Service Technical Information

MODEL NO. AM-F70 / F65
SUBJECT "Caution!" display appears.

REF.No. :G - 99 - 019 - E0

DATE :02. JUN. 1999

Fig. 1

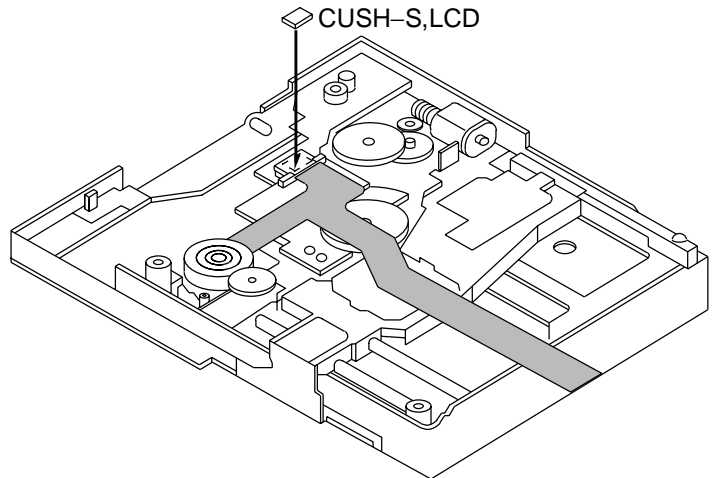
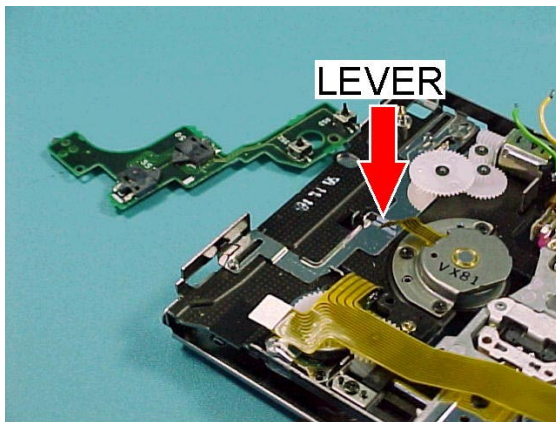
- If the lever runs on to OWH UP SW(S50) (See Fig.1):
 Remove the lever away from the switch, and then affix a cushion (CUSH-S, LCD) on to the connector of PWB, MECH (CN50).
